Item No. 5 Amendment to Development Agreement AG 51/05 - Sage Creek (St. Boniface Ward) File DASZ 32/2007

Re: **Requested amendment to Development Agreement AG 51/05 (Sage Creek)**
Qualico Developments (Winnipeg) Ltd.

Re: Qualico® - Sage Creek Subdivision – Tansi Lane

FIG "A"

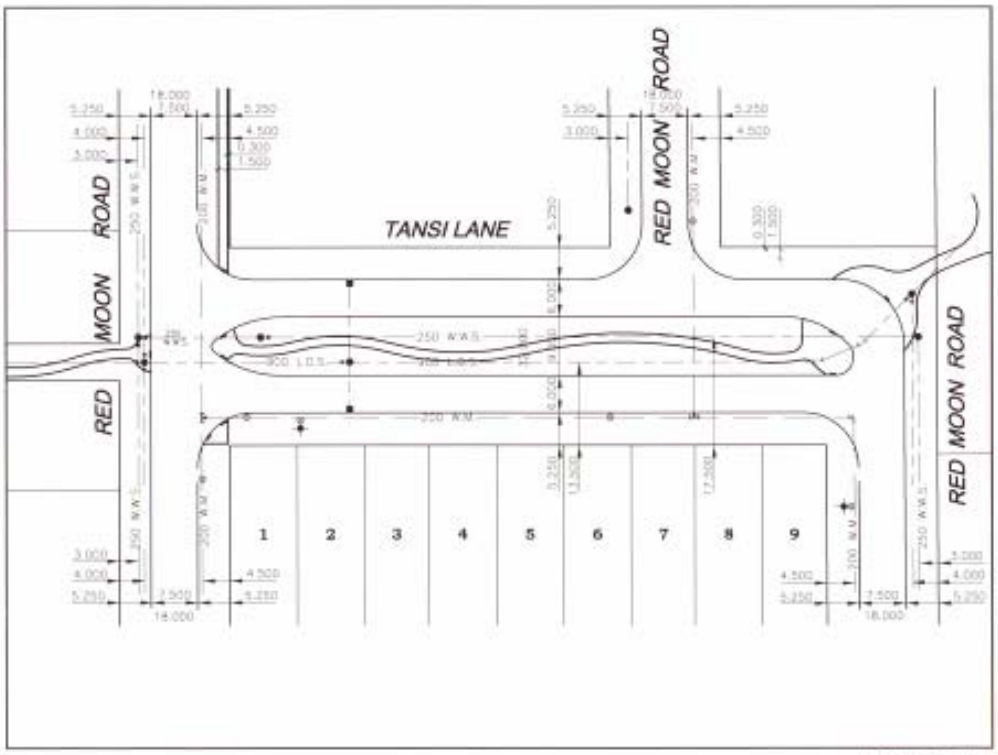
An issue has arisen regarding a request from Public Works to construct a public sidewalk on both sides of Tansi Lane which connects the north and south legs of Red Moon Road. Refer to Figure "A" attached.

At a significant cost to the Developer, Tansi Lane was constructed as a twin 6.0m pavement residential street with a wide median separating the two lanes to provide an "open" feel to the street with a central landscaped focal point, and at the same time contribute to the uniqueness of the neighbourhood. The Developer has a strong concern that public sidewalks would have a negative affect on the character of this street, given the 101' building setback. Refer to Figure "B".

This street could have been designed as a standard 7.5m roadway / 18m Right-of-Way as there was not a requirement for the twin pavement here for emergency second access. In accordance with City Standards, a typical residential street such as this would not require sidewalks.

- Reduced maintenance requirements for the City,
- Increased snow storage,
- A public walkway has been provided in the center median which connects with the developments pathway and park system,
- Four party utility servicing is installed on the 1.5m alignment on both sides.

The Public Works Department has no objection to deleting the requirement for 1.5m by 100mm sidewalks on both sides of Tansi Lane in consideration that the centre median pathway satisfies the sidewalk requirements at this location.
